City of El Paso – City Plan Commission Staff Report

Case No: SUSU11-00117 Franklin Hills Unit Eight
Application Type: Major Preliminary
CPC Hearing Date: December 15, 2011

ATTACHMENT 4

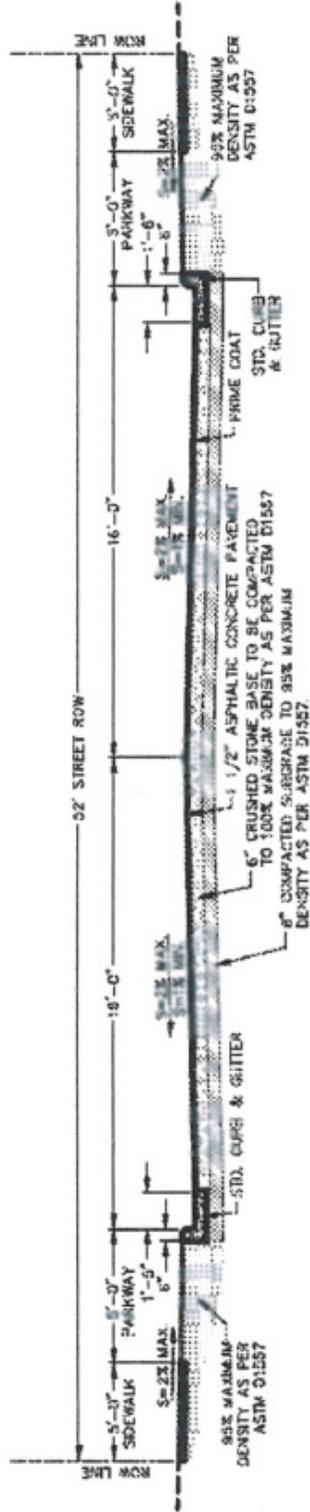
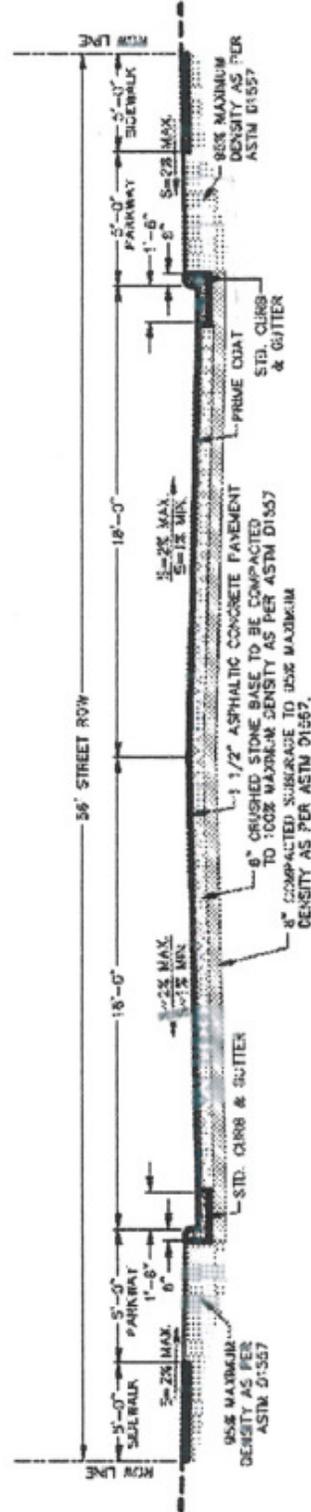
- To use a 52-ft right-of-way, with 32-ft of pavement, a 5-ft parkway, and 5-ft sidewalks
- To use a 56-ft right-of-way on Hidden Desert, with 36-ft of pavement, a 5-ft parkway, and 5-ft sidewalks
- To allow for street names in excess of 13 characters.

Quantum Engineering Consultants, Inc., on behalf of our client, Sun 262 Partners, Ltd., respectfully requests that we be allowed to use a 52' Right-of-Way width which would accommodate a thirty-two foot (32') paved section (32' local residential 3 section under current code) with a five (5') parkway and five (5') sidewalk on both sides. Our request also includes the use of a fifty-six foot (56') Right-of-Way width (specifically for hidden Desert Circle) which would allow a 36' paved section with a five foot (5') parkway and a five foot (5') sidewalk on both sides for a cul-de-sac length that exceeds three hundred (300) feet.

The Development Coordinating Committee recommends *approval* of the modifications under Reason 3 of Section 19.04.170.A of the previous Subdivision Ordinance and *approval* of Franklin Hills Unit Eight on a **Major Preliminary** basis subject to the following conditions and requirements:
